Landscape Review Committee
Community Development Center, 231 NE 5th Street
October 18, 2017
12:00 PM

DATE: October 18, 2017
TO: Landscape Review Committee Members
FROM: Chuck Darnell, Associate Planner
SUBJECT: Agenda Item 4A: L 2-17

A revised landscape plan for the construction of a new industrial building (L 2-17) to be reviewed by the Landscape Review Committee.

The revised landscaping now proposed on the portion of the site being developed can be seen below:

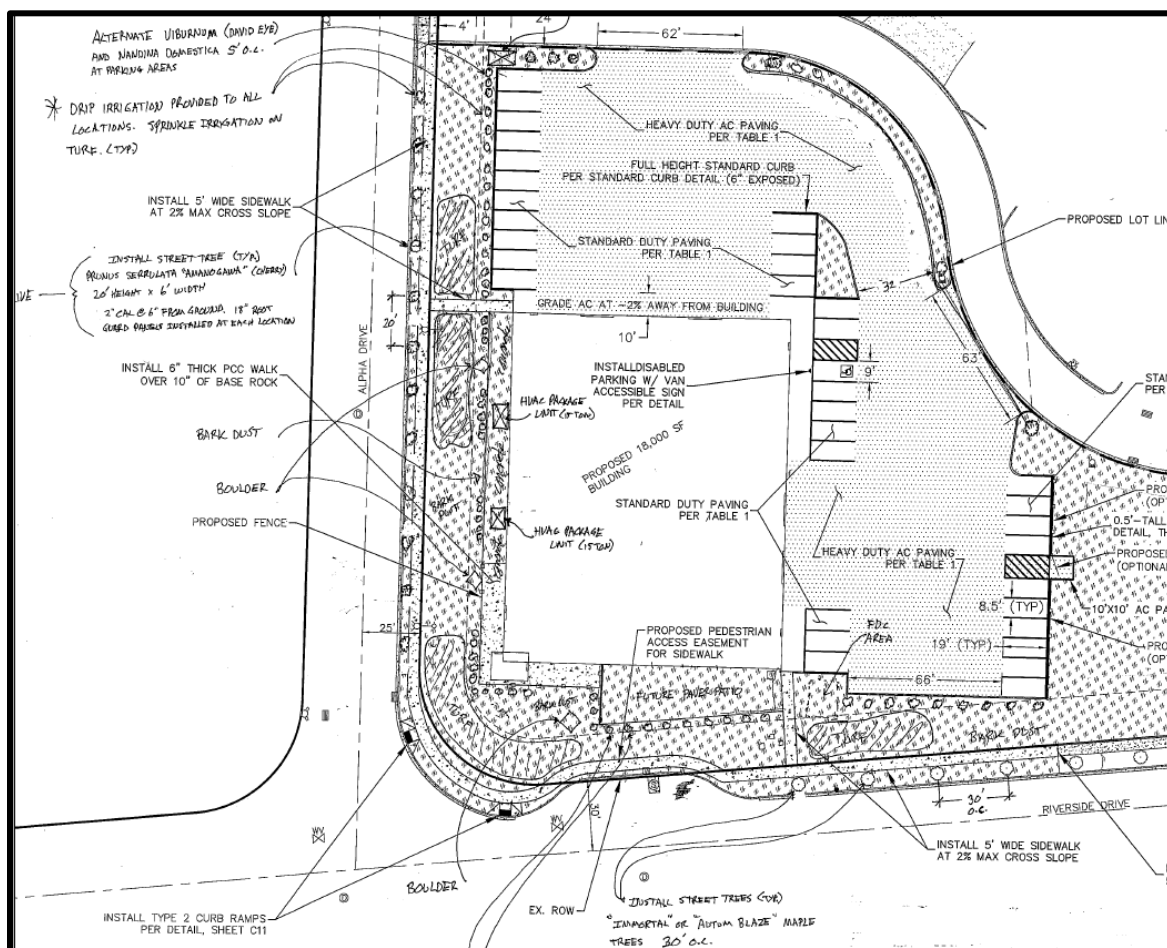
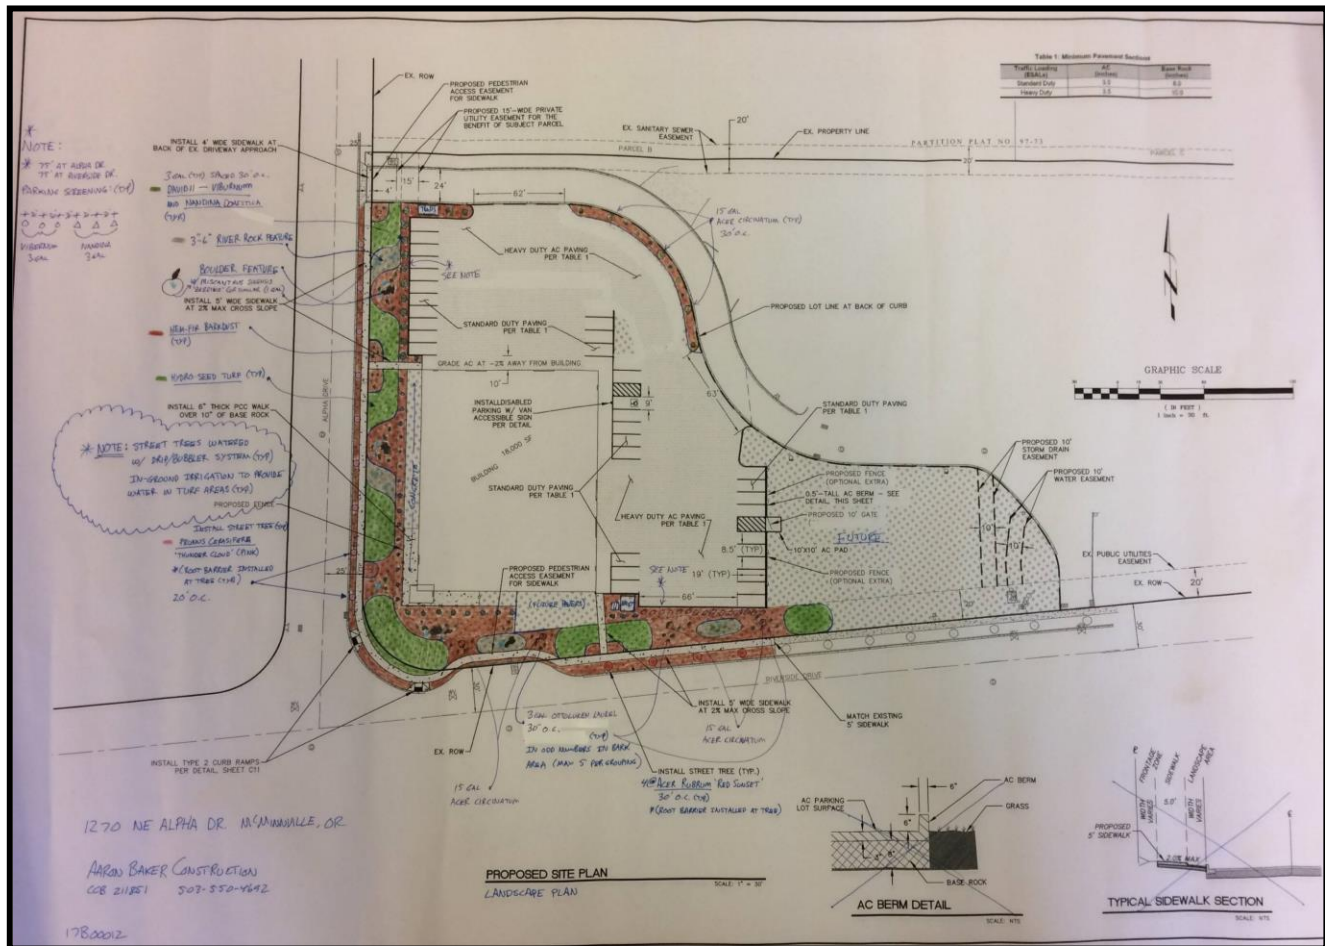
The Landscape Review Committee reviewed a revised landscape plan for this development at their September 20, 2017 meeting and continued the application to allow the applicant to make revisions to the plan to better meet the landscape plan review criteria in Section 17.57.070(B)(1) and Section 17.57.070(B)(2) of the McMinnville Zoning Ordinance. Specifically, the Landscape Review Committee had concerns with the proposed screening of the parking lots on the site. The Committee also had concerns with the planting densities throughout the site, and asked the applicant to provide more detail on specific plant species and spacing of the plants at installation.

The remainder of the site is proposed to be landscaped along the building perimeter and along the edges of the parking lots that will be most visible from the public right-of-way. The applicant is proposing to install David Viburnum (*Viburnum davidii*) and Heavenly Bamboo (*Nandina domestica*) along the base of the building on the west side and near the southwest corner of the building. The applicant has provided information on the spacing and pattern of these shrubs. The David Viburnum and Heavenly Bamboo will be planted 30 inches apart on center, and will be planted in a continuous row, alternating by groups of three (3) of each shrub. This planting pattern will be used on the west side of the northern parking lot and south side of the southern parking lot. A condition of approval is included to require that the spacing and alternating of these shrubs be continued along the west and south sides of the building, because as they are shown on the plan they will be space nearly 10 (ten) feet apart in some locations which will not provide adequate screening.

The landscape plan does not include substantial landscape islands in the parking areas, but the parking areas on the site are fairly well spread out throughout the site. There is not a large expanse of parking areas in any single location on the site, which reduces the visual impact of the parking areas without breaking them up with additional landscaping. The applicant is proposing to install a row of Otto Luyken's Laurel (*Prunus laurocerasus* 'Otto Luyken') within the planting area along the access drive on

the north side of the site. In response to the Committee's previous comments on the minimal plantings in this area, the applicant has added three (3) Vine Maple (*Acer circinatum*) trees. This will provide for additional buffering between the site's parking areas and the adjacent property.

The street tree plan shows an evenly spaced planting pattern. The Thundercloud Flowering Plum tree grows to a mature height of 15 - 20 feet and a canopy width of 15 - 20 feet. Based on those sizes, the

McMinnville Zoning Ordinance defines the Flowering Plum as a small or narrow stature tree, and requires that the trees be spaced no greater than 20 feet apart (Section 17.58.090(C)). The landscape plan as proposed shows the trees being planted 25 feet apart, so a condition of approval has been added to reduce the spacing to 20 feet apart on center. The applicant is proposing to install Red Maple (*Acer rubrum* 'Red Sunset') trees along NE Riverside Drive, spaced at 30 feet, to be consistent with existing street tree plantings to the east. This spacing is consistent with the requirements for a medium tree.

Utilities were not identified on the street tree plan, but a condition of approval will be included to ensure that the street trees will meet the required setbacks from each type of utility and the driveway.

3. That the David Viburnum (*Viburnum davidii*) and Heavenly Bamboo (*Nandina domestica*) planting pattern proposed on the west side of the northern parking lot and the south side of the southern parking lot be continued along the west and south perimeters of the new building.

5. That the Flowering Plum (*Prunus cerasifera* 'Thundercloud') trees along NE Alpha Drive shall be planted no more than 20 feet apart on center.
6. All trees shall be healthy grown nursery stock with a single straight trunk, a well developed leader with tops and roots characteristic of the species cultivar or variety. All trees must be free of insects, diseases, mechanical injury, and other objectionable features when planted.

7. That each street tree shall be provided with root barrier protection in order to minimize sidewalk and tree root conflicts. The barrier shall be placed on the public sidewalk side of each tree and the curb side of each tree. The root barrier protection shall be placed in 10-foot lengths, centered on each tree, and to a depth of eighteen (18) inches. In addition, all trees shall be provided with deep watering tubes to promote deep root growth (see enclosed detail).

The revised landscaping now proposed on the portion of the site being developed can be seen below:

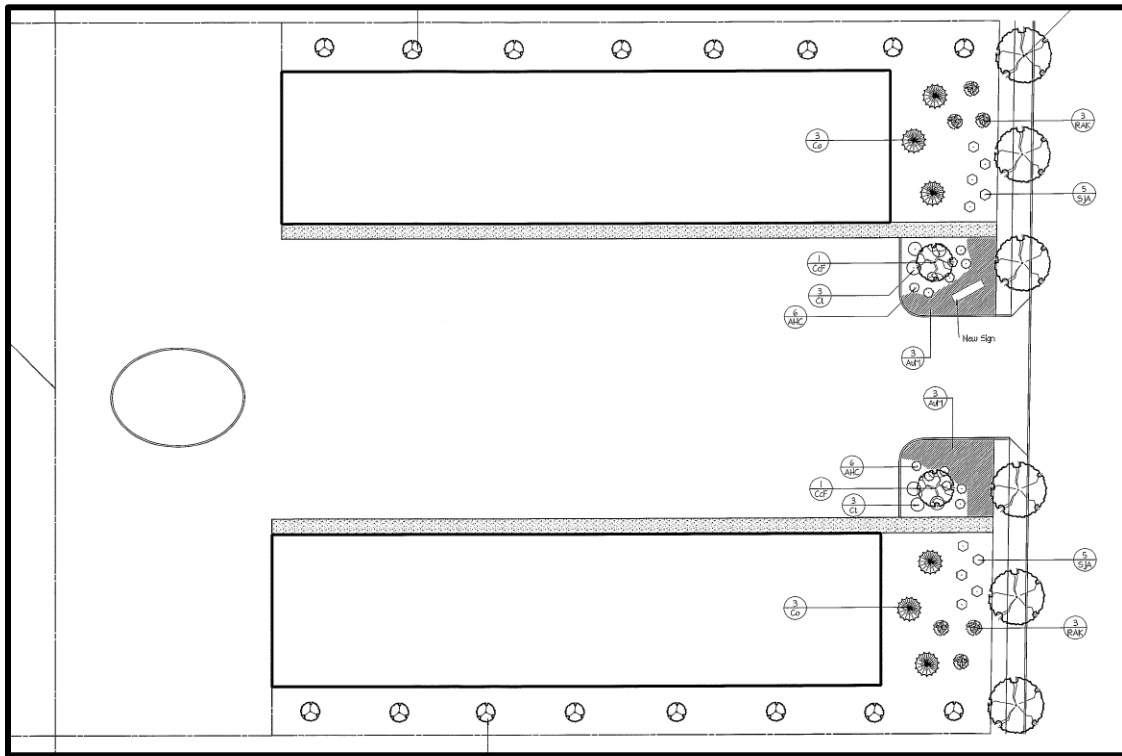
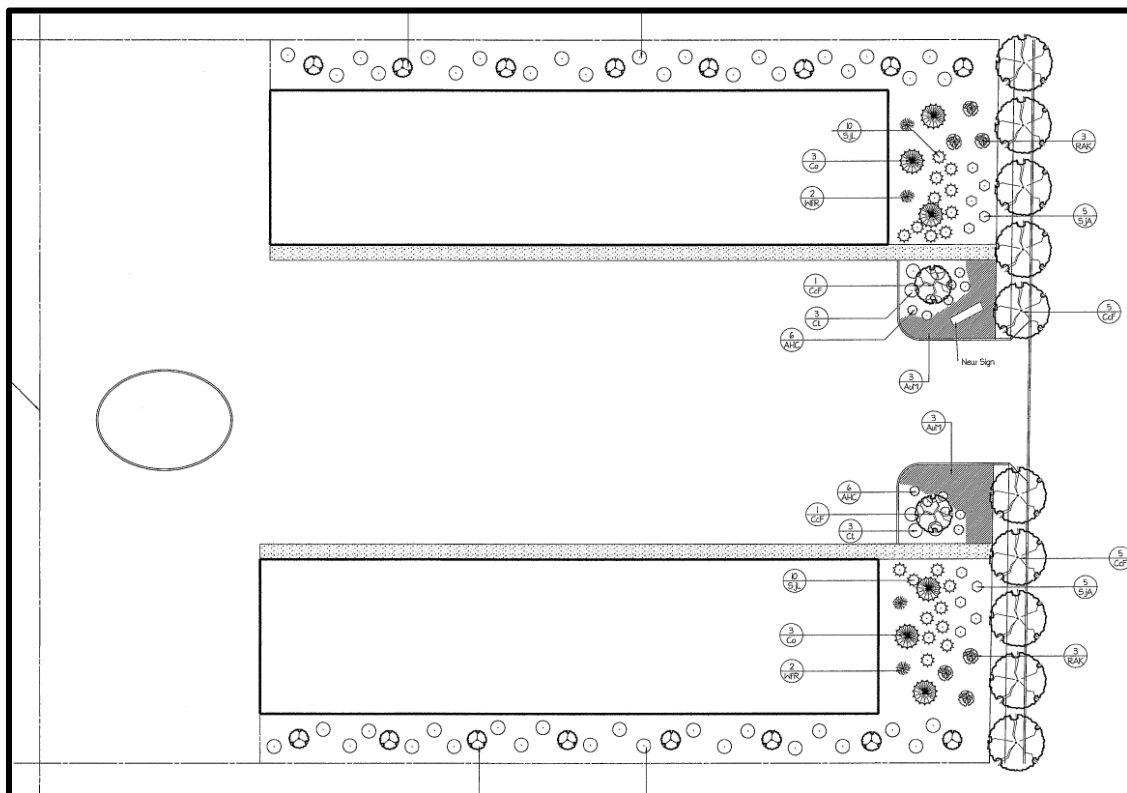
In response to the continuance of the original landscape plan and to better meet Section 17.57.070(B) (Area Determination – Planning Factors) of the McMinnville Zoning Ordinance, the applicant has

Finding: Utilities were not identified on the street tree plan, but a condition of approval will be included to ensure that the street trees will meet the required setbacks from each type of utility and the driveway.
